Mr Daniel Westerman
Chief Executive Officer
Australian Energy Market Operator

Submission to Draft 2024 Integrated System Plan

The Centre for Independent Studies (CIS) appreciates the opportunity to provide a submission to the Australian Energy Market Operator.

Figure 4. Retirement/rehabilitation cost estimates of different generation technologies in the Draft 2024 ISP.¹⁴¹

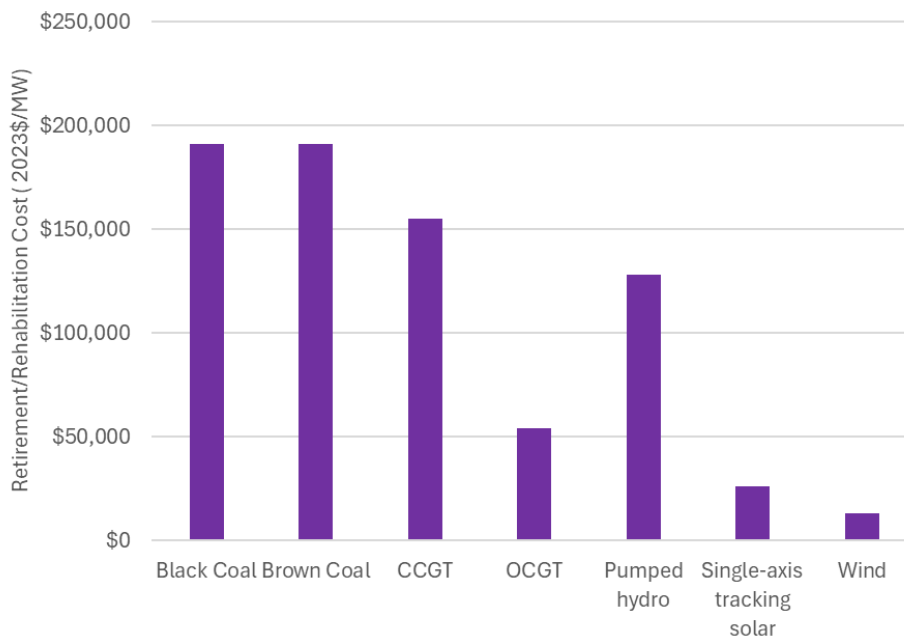
The effect of not including these crucial asset life costs is that the retirement/rehabilitation cost estimates the Draft 2024 ISP uses for coal and combined cycle gas turbines are several times higher than that of the underestimated solar and wind costs (see Figure 4).

Figure 5. Net market benefits of the least-cost DP relative to the counterfactual DP under Step Change, with years sampled for reliability analysis indicated.¹⁶⁶

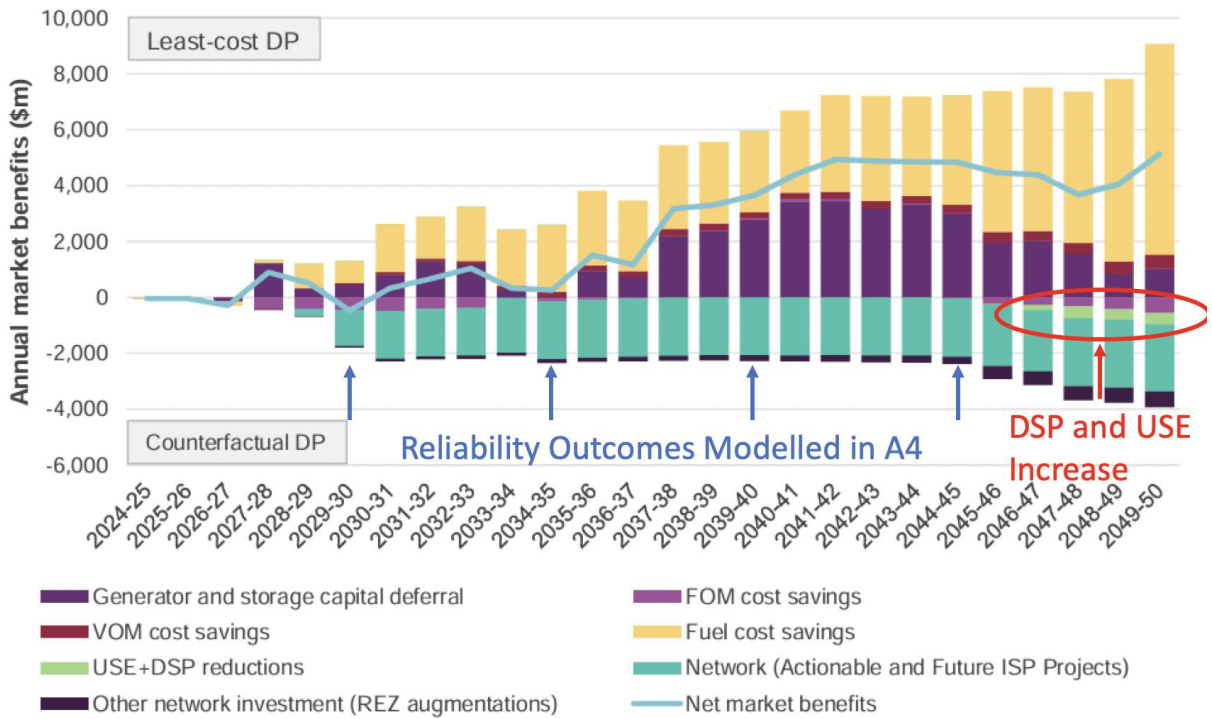
AEMO forecast reliability outcomes for the Draft 2024 ISP but the Draft’s Figure 32 indicates this was only done for the years 2029-30, 2034-35, 2039-40 and 2044-45.¹⁶⁵ This means there is no guarantee of meeting the reliability standard for every year not analysed, particularly those following 2044-45 up until the end of the modelling horizon. Given it’s clear in the cost benefit analysis that the costs of Demand Side Participation and Unserved Energy begin to rise just after the end of this window, it appears this selective choice of years masks that the model does indeed actually fail to meet reliability standards, even with the installed capacities having the benefit of effective perfect foresight (see Figure 5).

Figure 6. Gas capacity for mid-merit gas and flexible gas across the NEM in the Draft 2024 ISP ODP under Step Change.¹⁷¹

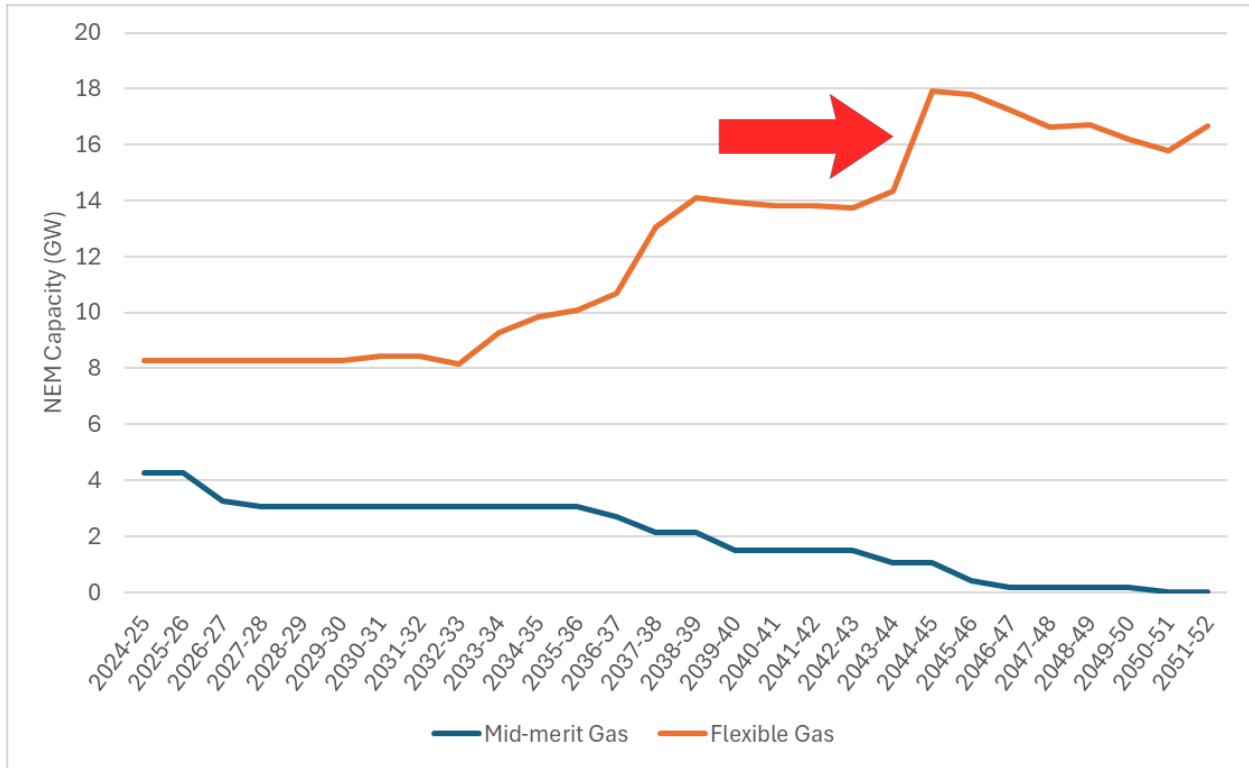
AEMO allows the model to “build flexible gas to take into account those chances of unserved energy,”¹⁶⁹ but assumes “perfect foresight” of VRE output and demand for each day.¹⁷⁰ The model not only assumes perfect foresight within each day but also across years, as evidenced by the pattern of flexible gas capacity exhibited in the Draft 2024 ISP model (see Figure 6).

There is a sudden increase of 4 GW in one year to ensure there is a peak of 18 GW of capacity in 2045 — the exact year in which solar capacity factors across most solar farms experience a marked drop (see Figure 7). This appears to show a high degree of overfitting in the model to make generation, and the timeline of gas plant builds in particular, fit exactly to a specific sequence of weather years. If a different sequence of weather years were used, e.g., with the bad solar year occurring a few years earlier, there may not be enough flexible gas capacity to ensure grid reliability.

Figure 7. Solar capacity factors for solar farms across the NEM in the Draft 2024 ISP ODP under Step Change.¹⁷²

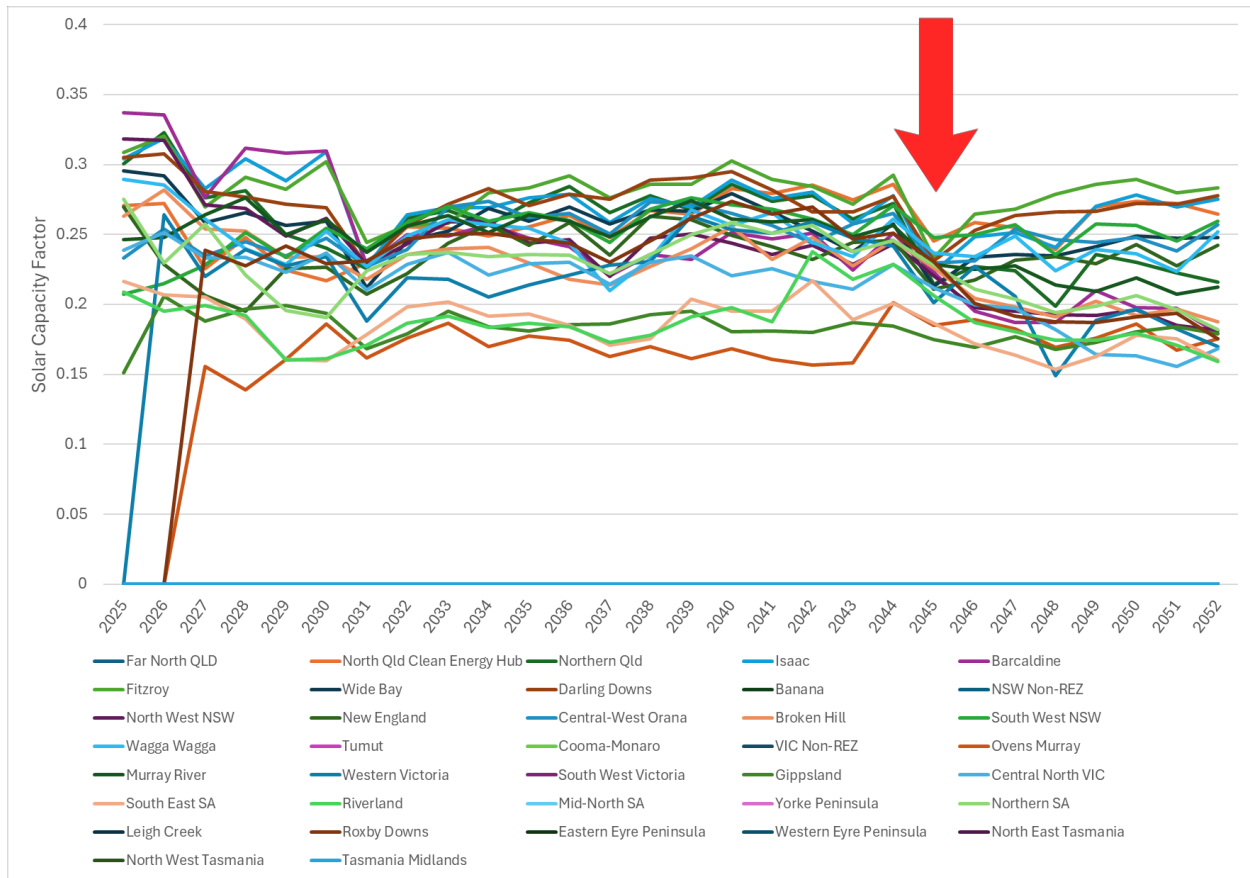
Furthermore, following the more demanding weather-year in 2044-45, which drives nearly 4 GW of additional peaking gas being installed for that year, the ODP projects that approximately 4 GW of shallow battery storage can be immediately retired the following year, precisely 20 years (the full battery life) after being installed. This creates a significant discontinuity in the overall capacity of installed storage in the NEM, and is clearly an artefact of the particular demands of particular weather years being effectively known with unlimited foresight in the model's optimisation algorithm. A credible and realistic plan for the NEM must account for the fact that it is impossible to know exactly in which year such challenging weather events will arise, and a reliable system will require that we are ready for any weather year every year.

Figure 10. Comparison of capacity with HumeLink (2029-30) and without HumeLink in Step Change.²⁴⁰

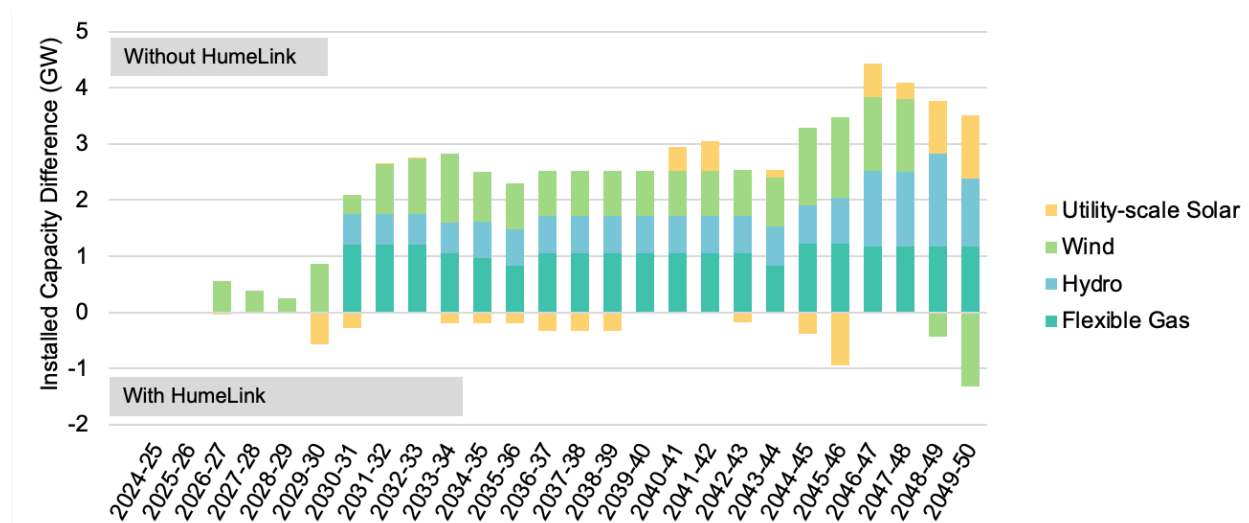
The Draft 2024 ISP's cost benefit analysis posits that implementing HumeLink would yield significant market benefits by deferring the capital expenditure needed to construct gas power plants, pumped hydro, and onshore wind as coal plants in New South Wales are aggressively decommissioned by 2037-38 to meet the cumulative carbon budget target. To quote the cost benefit analysis from Appendix 6:

As noted in the Draft 2024 ISP, the modelled installed generator capacity difference in the Draft 2024 ISP significantly diverges from the 2022 ISP results. In the Draft 2024 ISP, pumped hydro and peaking gas were deemed the next best alternative to an actionable HumeLink.

Figure 14. Rise in construction cost increase fails to explain \$1,059 million of HumeLink’s relative benefits in capital deferral savings.

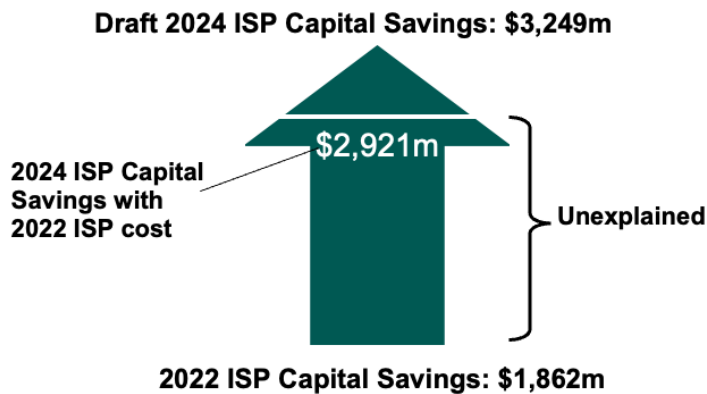
The prices of batteries have increased significantly more in the change between 2022 and 2024 assumptions. It is noted in the 2024 draft that the switch to pumped hydro storage was necessitated partly by an increase in battery costs and hence the increase in battery prices might place an upper-bound on the cost of the switch from batteries to hydro. However, even when replacing the hydro capacity of the 2024 ISP with batteries, taking the weighted mix of battery storage depths from the 2024 ISP, we find that battery changes only account for a slightly larger amount. In total, increases in capital costs even accepting this battery replacement can only explain approximately \$328 million, or 10% of the increase in HumeLink’s market benefits (see Figure 14 below).

We therefore conclude that increases in the capital savings are not due to price rises, but mostly due to increases in the volume of capacity in this particular model, which we will discuss later.

Figure 16. Adjusting fuel cost savings in 2024 HumeLink TOOT analysis for changes in gas price forecast since 2022 ISP.

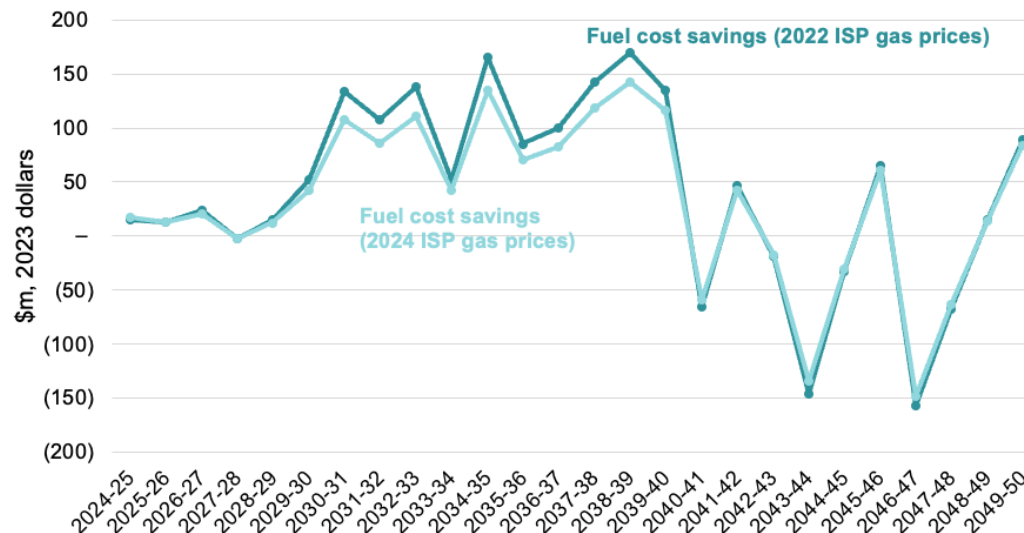
This explanation is puzzling. The Draft 2024 ISP predicts lower gas prices for power generation compared to the forecasted prices used in the 2022 ISP for most of the outlook period. Therefore, to the extent that gas usage is considered as an alternative to HumeLink, this price change doesn't significantly boost the benefits of HumeLink.

Figure 17. Recalculated NPV of HumeLink delivered at planned in-service date.

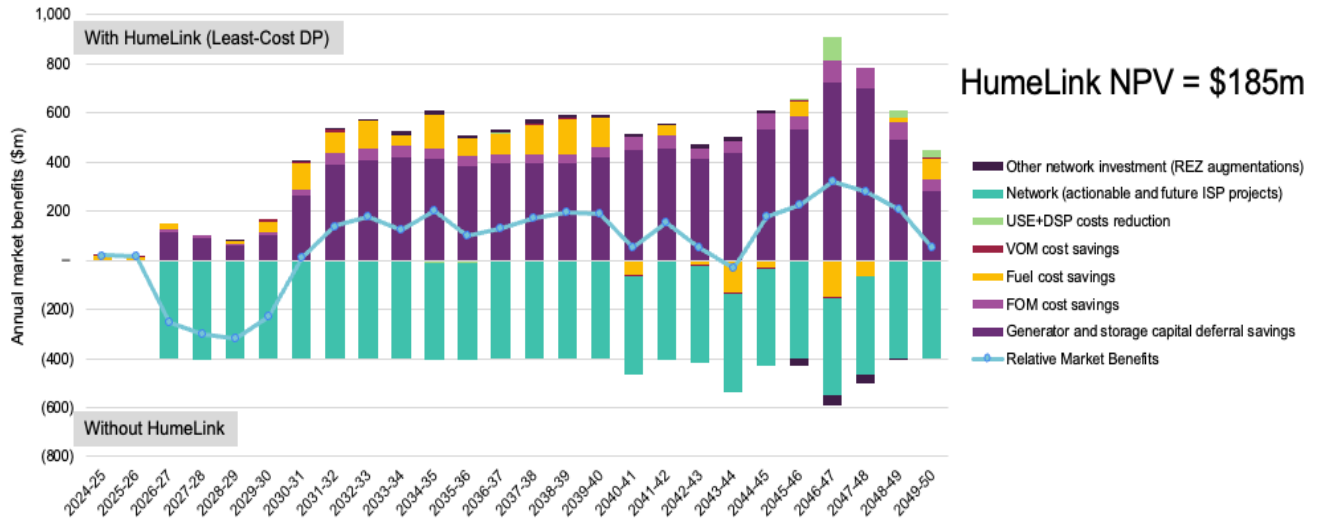
Delaying HumeLink's delivery from 2026-27 to 2029-30, as projected in the 2024 TOOT analysis, has a critical impact. Pushing back HumeLink's costs by three years significantly lowers discounted network expenses, increasing its net market benefits. Our calculations indicate that reverting HumeLink's delivery timing to 2026-27 would greatly reduce its net market benefits, from \$1 billion to just \$185 million. Combined with other factors discussed, this would likely make HumeLink's net present value negative, endangering its business case.

Figure 19. Capacity factors for solar in REZs in Draft 2024 ISP ODP, with years of low solar output marked.²⁵⁰

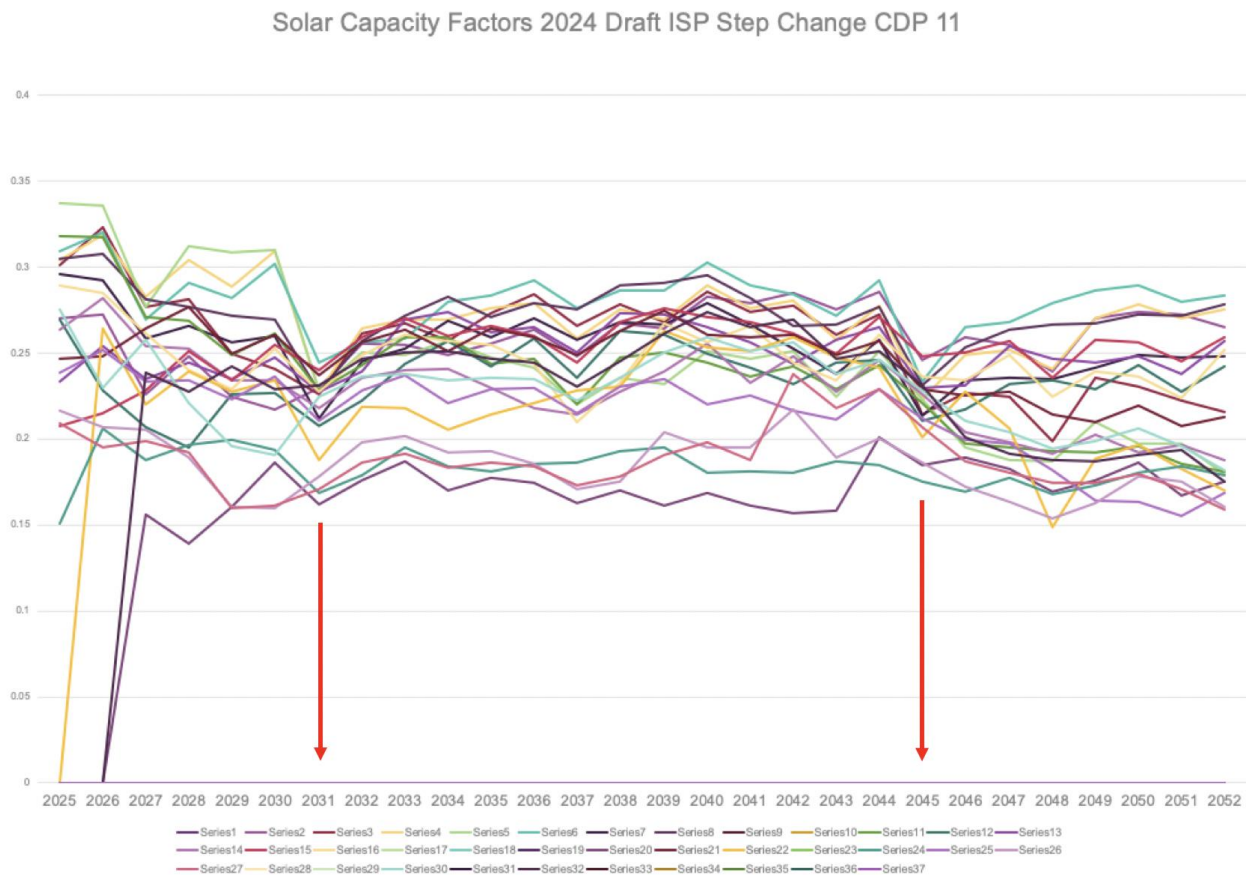
As discussed earlier, an examination of the capacity factors for solar across all of the REZs demonstrates some conspicuous years, almost certainly corresponding to La Niña events, when solar output is generally lower. In the 2024 Draft ISP the most severe of these occur in 2030-31 and 2044-45, as can be seen from the consistent depression of capacity factor in these years.

Figure 21. Timing comparisons for key events around HumeLink in 2024 Draft ISP ODP.²⁵²

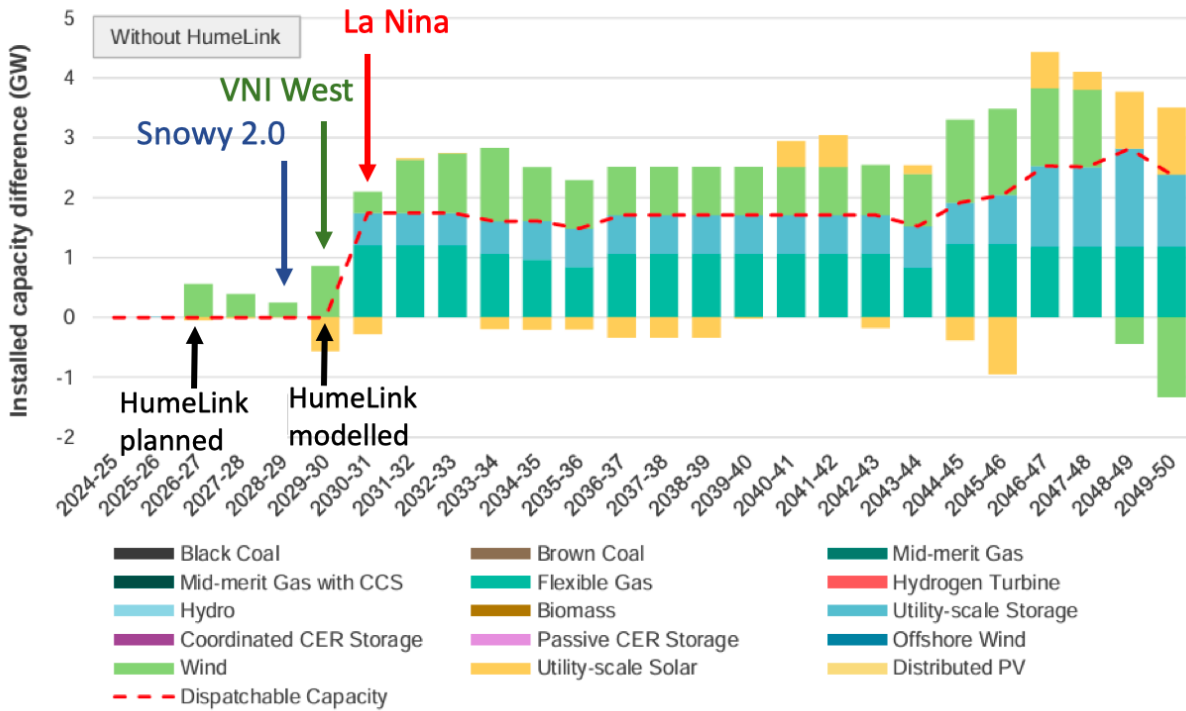
This demonstrates an idealised timing for HumeLink, falling directly between the anticipated completion of Snowy 2.0, and the La Niña event which imposes the strongest demands for alternative capacities without HumeLink.
